Executive Director's Recommendation

Commission Meeting: June 6, 2019

PROJECT Naval Support Activity Bethesda, Uniformed Services University of the Health Sciences Education and Research Building Naval Support Activity, Bethesda 8901 Rockville Pike Bethesda, Maryland	NCPC FILE NUMBER 7987 NCPC MAP FILE NUMBER 3101.30(38.00)44934 APPLICANT'S REQUEST Approval of revised preliminary site and building plans
SUBMITTED BY United States Department of Defense Department of the Navy	PROPOSED ACTION Approve revised preliminary site and building plans
REVIEW AUTHORITY Federal Projects in the Environs per 40 U.S.C. § 8722(b)(1)	ACTION ITEM TYPE Open Session

Approval of Preliminary Site and Building Plans

Landscape Plan

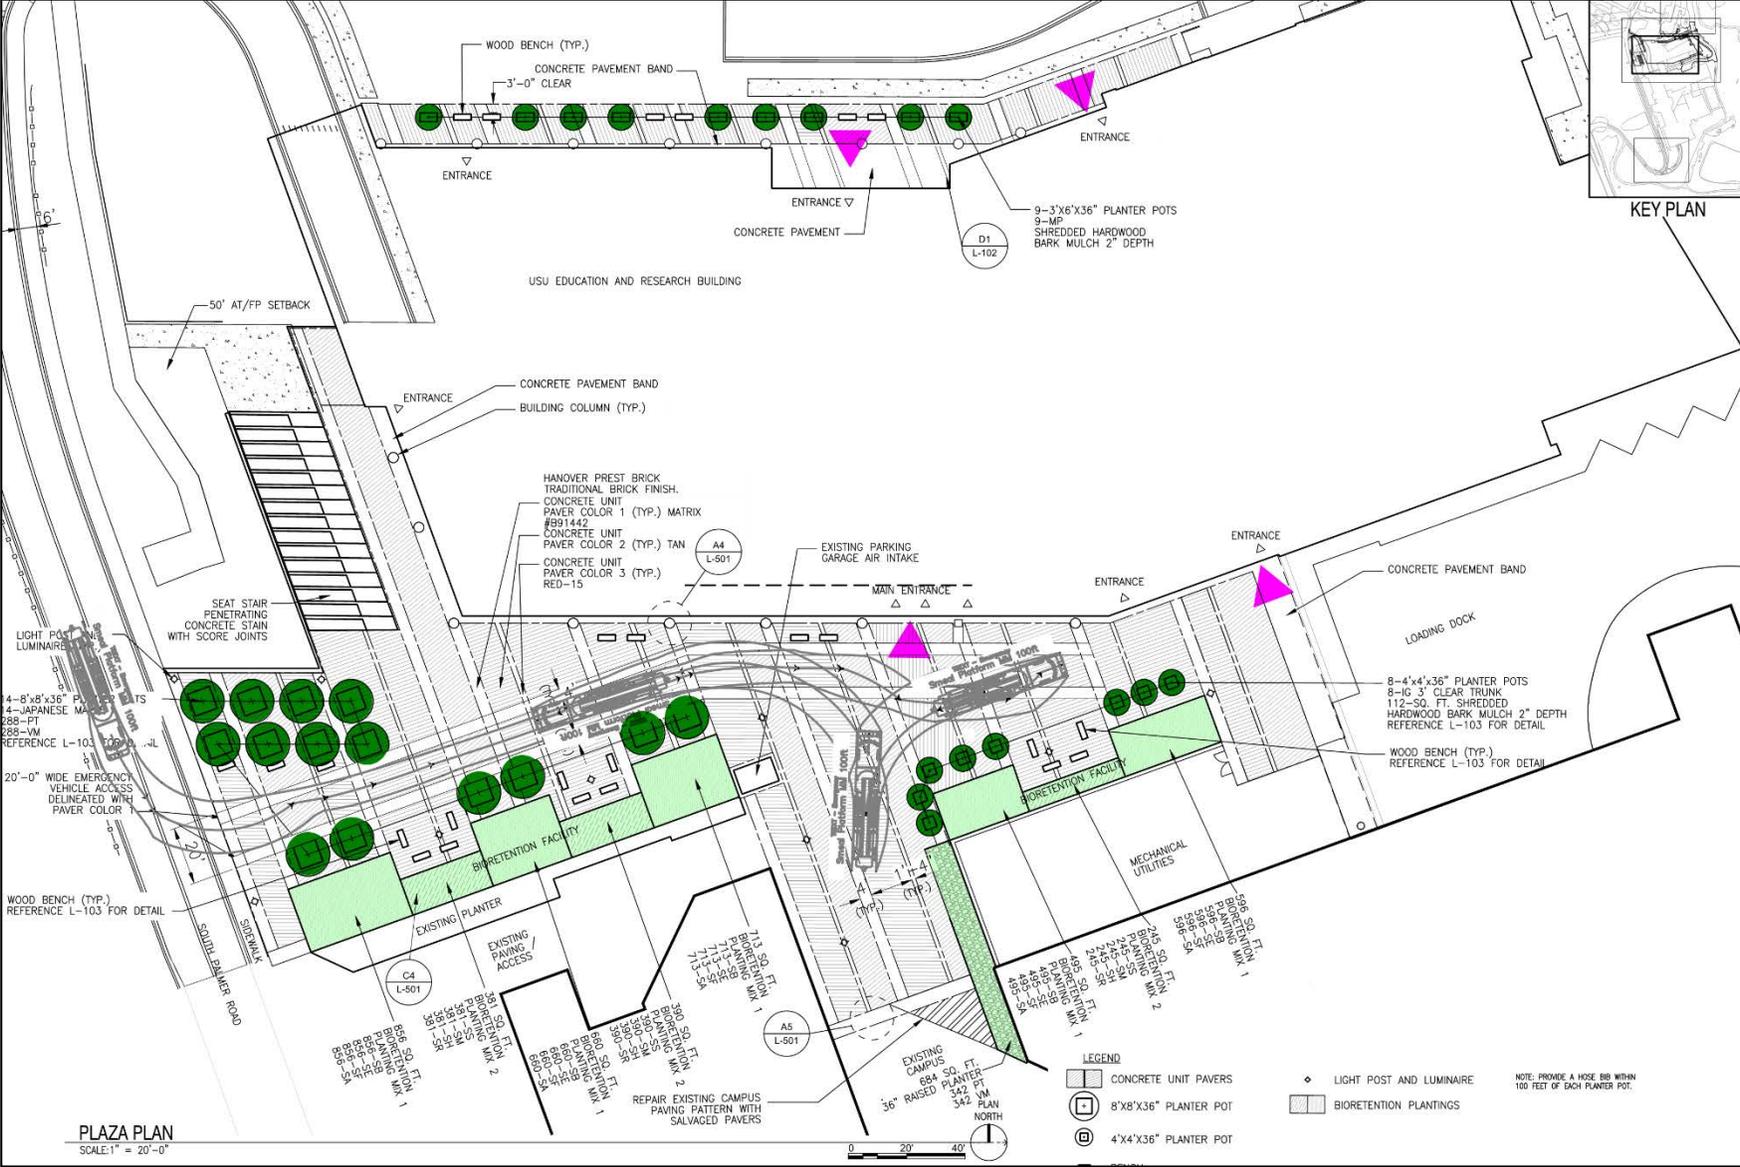
Notes that development constraints on the eastern plaza, including a subsurface radiobiology lab and emergency vehicle access route, limit the amount of additional landscape that can be provided at this location, but that tree planters are proposed in lieu of planting beds.

Finds that the proposed trees on the eastern plaza would not provide adequate shade relief.

Requests that the applicant consider the use of tables, chairs, and either built-in or non-permanent shade structures to provide further seating and shade relief on the eastern plaza.
